Lighthouse Green Fuels

Development Consent Order

PEIR Addendum (April 2026)

Planning Inspectorate Reference: EN0110025

Drawing Title
PEIR Addendum Figure A3.1
CO₂ Export Connection Options

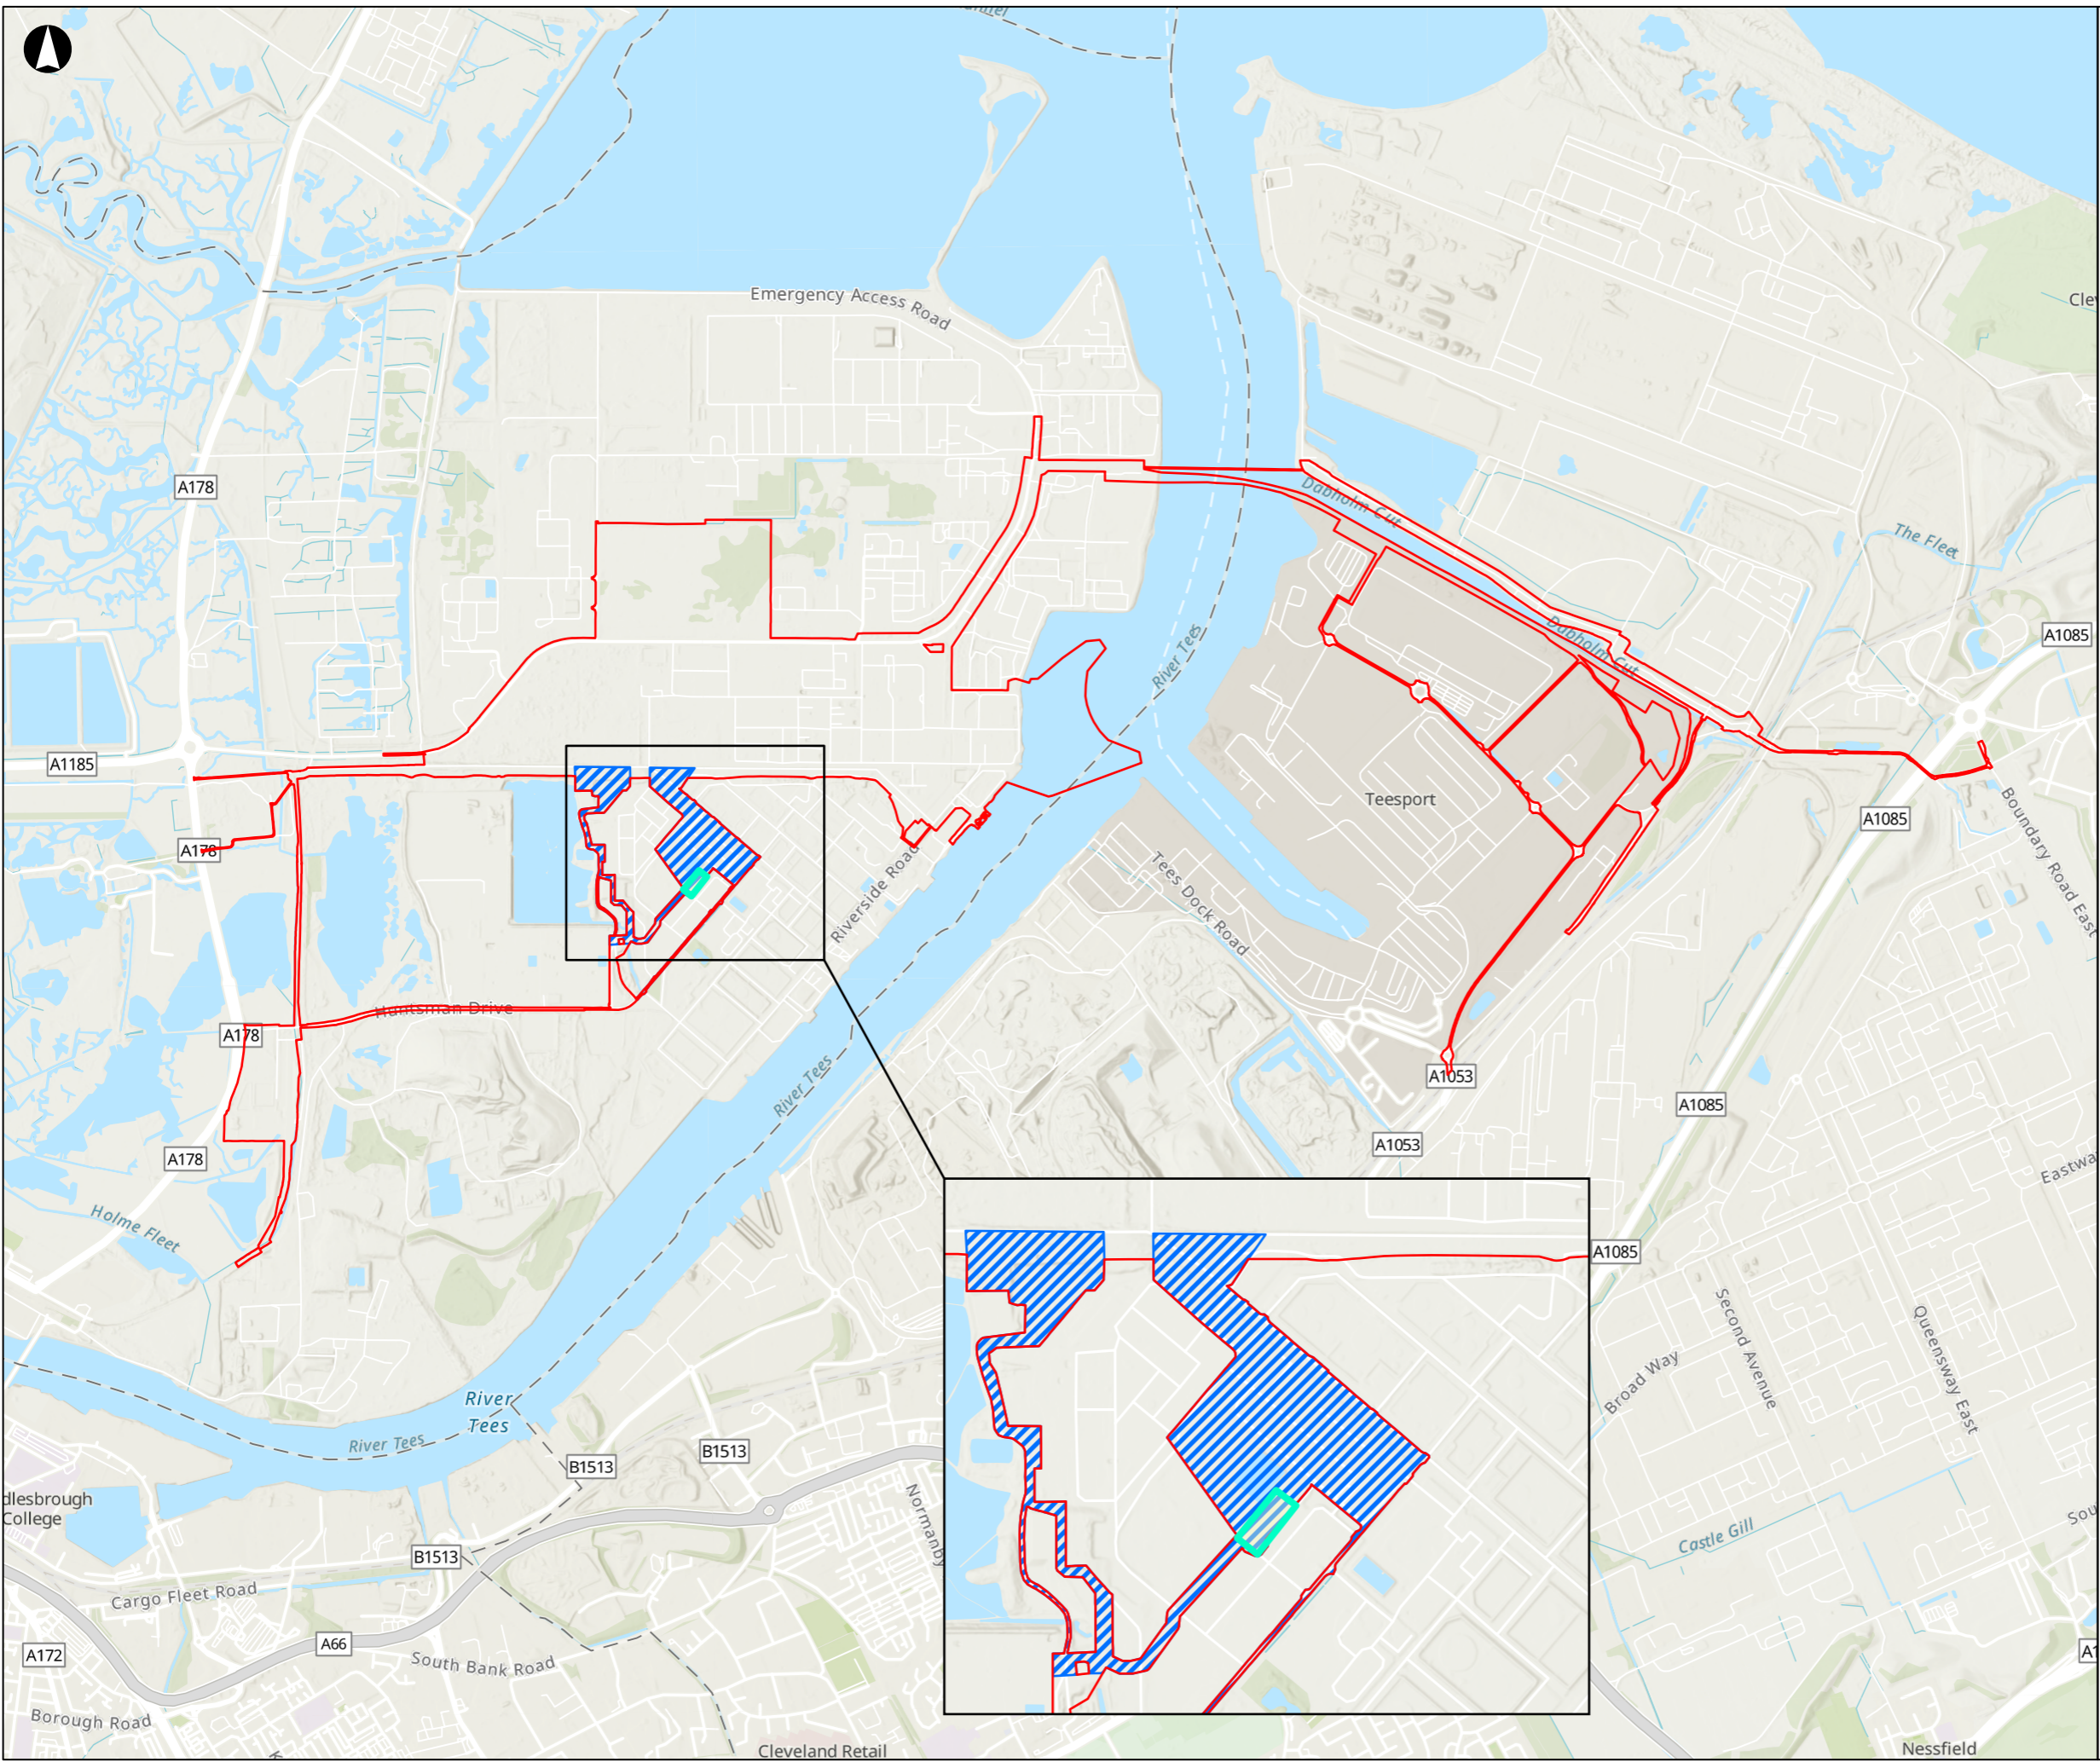
- a pipeline from the Main Site to the consented NEP AGI-C1 which is located to the south of the Main Site on third-party land and Sembcorp Pipeline Corridor (see Figure A3.1), or alternatively;
- a pipeline from the Main Site to the consented NEP AGI-C2 which is located in the Sembcorp Pipeline Corridor on third-party land (see Figure A3.1).

3.5.3 For Option 1, the connection to the south of the Main Site, this would involve construction of a metering compound within the Main Site and a connecting section of steel pipeline (approximately 100 m long) running southward from the Main Site to the delivery point at the separately consented NEP AGI-C1 (Figure A3.1). This new pipeline will need to cross the Sembcorp Pipeline Corridor which runs east-west to the south of the Main Site before connecting to the delivery point at NEP AGI C-1. The proposed connection works to the south of the Sembcorp Corridor are not within the draft Order limits and require additional land to be included within the Proposed Development boundary (Figure A3.1) both for the connection itself and for its construction.

3.5.4 The alternative Option 2 connection route to the north-east of the Main Site would also involve the construction of a metering compound and also a new steel pipeline running above ground from the Main Site in an existing pipeline corridor then northward along the existing above ground pipe track in the Sembcorp Pipeline Corridor to connect to the delivery point at NEP AGI C-2 located the north-east of the Main Site, also on third-party land (Figure A3.1). This change is entirely within the existing proposed Order limits.

- 3.6.1 Construction of Option 1 would involve construction of a new metering point within the Main Site and a connecting section of steel pipeline running southward from the LGF Main Site to the delivery point at the NEP AGI-C1 (Figure A3.1). This new pipeline will need to cross the Sembcorp Pipeline Corridor which runs east-west to the south of the Main Site. The pipeline crossing may be achieved using conventional trenchless techniques such as HDD.
- 3.6.2 Construction of Option 2 would involve the construction of a new steel pipe from a new metering point within the Main Site along the existing pipe rack in the Sembcorp Pipeline Corridor to connect to the delivery point at the NEP AGI-C2 to the north-east of the Main Site (Figure A3.1). Construction will be using conventional pipe handling and joining techniques.

Drawing Title
**PEIR Addendum Figure A3.2
 Off-Site Electrical Connection Options**

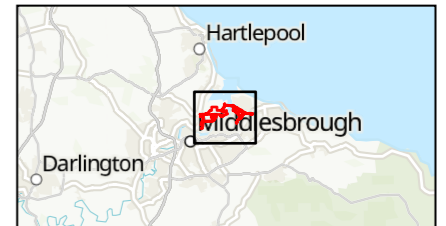
- 3.6.3 The connection works will require approximately 900m of buried electrical cables from the existing North Bank switchyard located within the Sabic Site to the south of the Main Site and then under the Sembcorp Pipeline Corridor to the Main Site using conventional construction techniques. The crossing of the Sembcorp Pipeline Corridor may require the use of compact HDD techniques (Figure A3.2).

- 4.3.10 Specifically, an updated PEA will be undertaken covering all new areas included within the updated Proposed Development boundary (Figure A3.2). This will inform an updated baseline and assessment of the relative importance of each Important Ecological Feature (IEF) and the magnitude of change arising from the Proposed Development (including the Proposed Development Changes). Similarly to the approach set out within the PEIR, measures will be incorporated to avoid and mitigate adverse effects and then an assessment on the significance of any residual effects after embedded mitigation will be undertaken as part of the full assessment to inform the Environmental Statement. Appropriate additional mitigation measures and opportunities for ecological enhancement will then be identified as part of the overall strategy for the Proposed Development.
